# **Official Transcript of Proceedings**

## **NUCLEAR REGULATORY COMMISSION**

Title:                   Advisory Committee on Reactor Safeguards  
                              Open Session

Date:                  Thursday, November 3, 2016

“White paper” – ML111030586

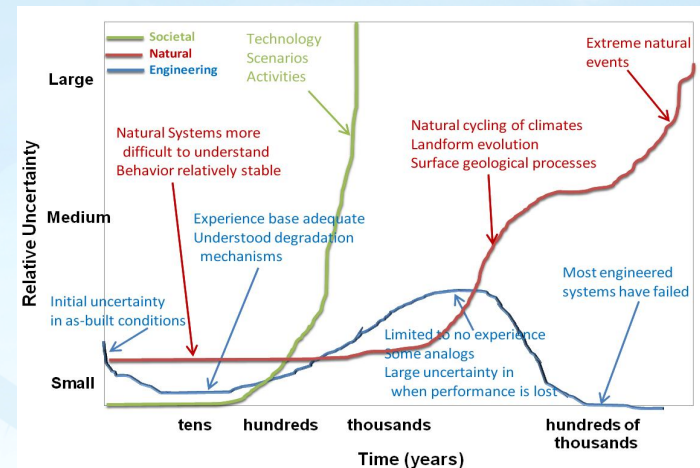
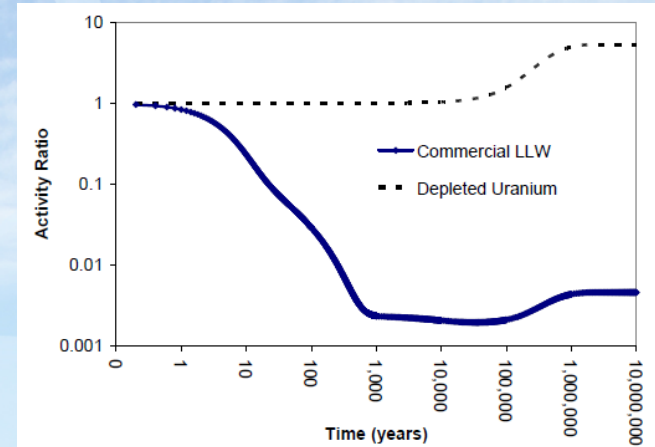
11 MEMBER REMPE: I was curious about this  
12 white paper, which I appreciated getting a copy of.  
13 But like this composites on the lower right was I  
14 guess a composite based on the earlier Figure 3,  
15 which had no axis on the different plots.

16 But it said the staff used their  
17 experience with waste disposal systems to generate  
18 Figure 3, which I guess was the basis for Figure 4.  
19 Some of the information in both of those figures is  
20 pretty precise.
